7.2 Reactor Protection (Trip) System (RPS)—Instrumentation and Controls

The information in this section of the reference ABWR DCD, including all subsections, tables and figures, is incorporated by reference with the following departures and supplements.

STD DEP T1 2.3-1 (Table 7.2-1, 7.2-2, Figures 7.2-2, 7.2-6, 7.2-9, 7.2-10)

Figure 7.2-6 Division 1 Trip Logic

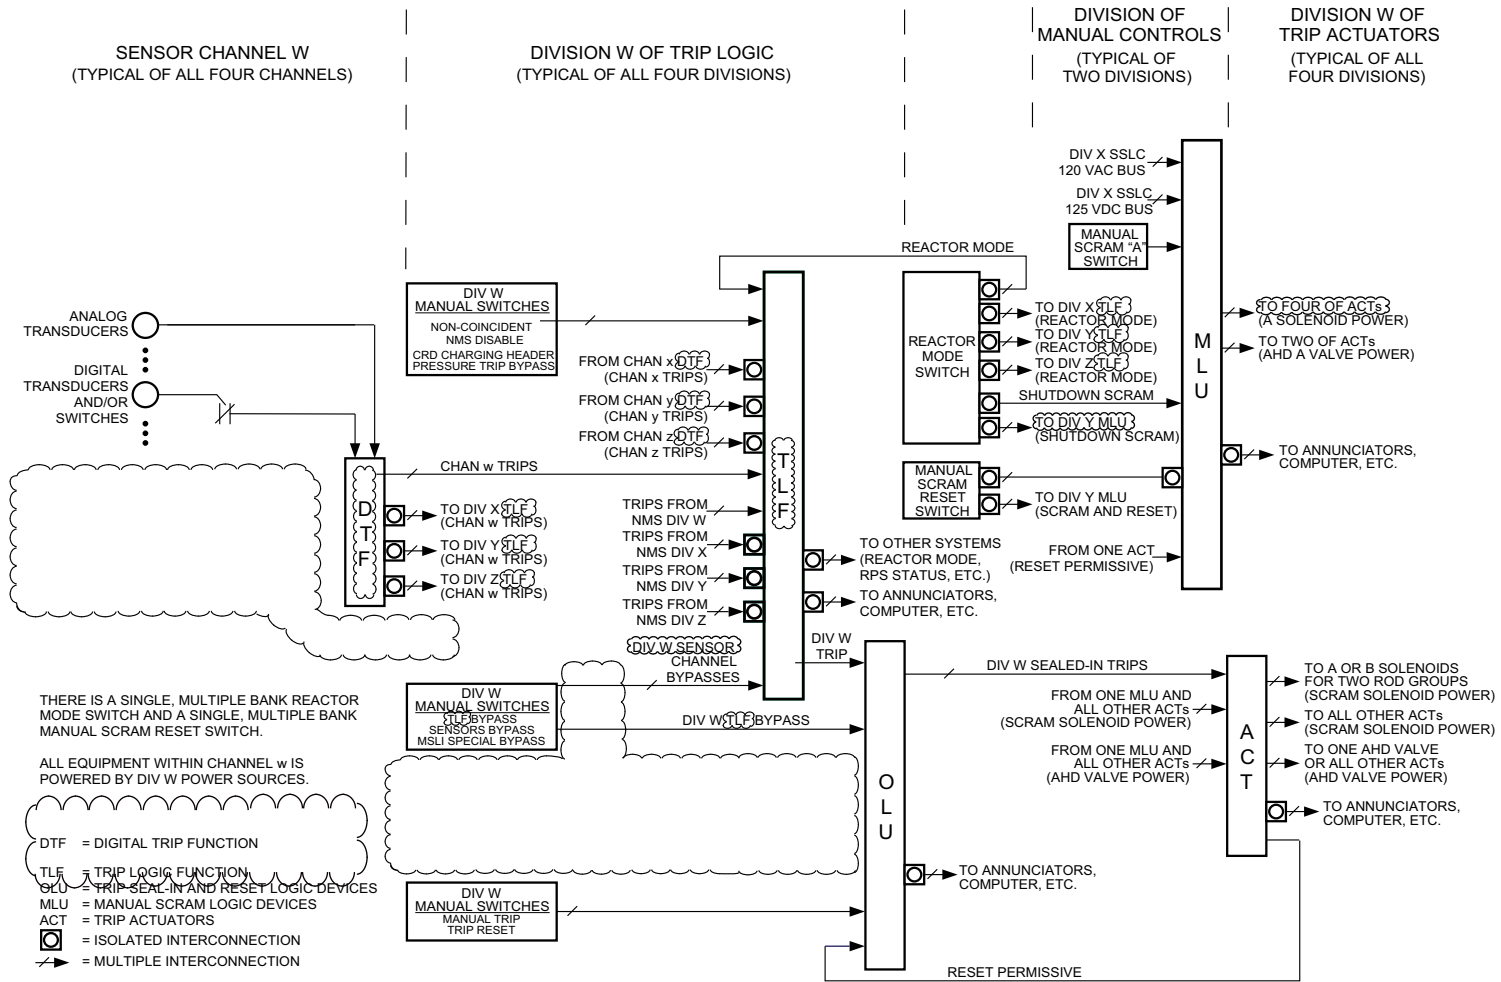
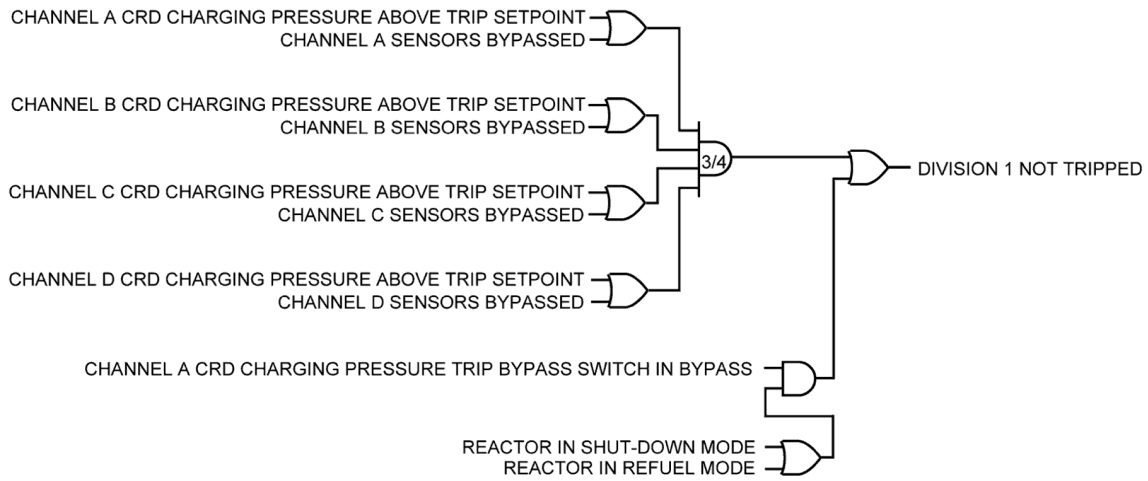
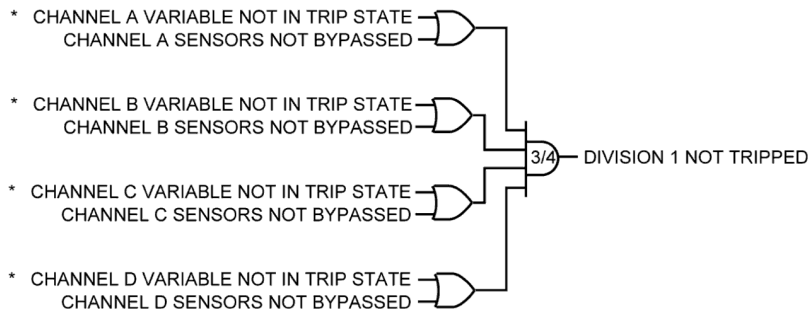
STD DEP T1 3.4-1 (Figures 7.2-2, 7.2-9, 7.2-10)

(3) Control Rod Drive (CRD) System (Figure 7.2-6)

(4) ~~Process Radiation Monitoring (PRM) System (Figure 7.2-6)~~ Not Used

~~Main steamline radiation is measured by four separate radiation monitors. Each monitor is positioned to measure gamma radiation in all four main steamlines. The PRM System then provides a separate bistable output to the DTM in each of the four RPS sensor channels.~~
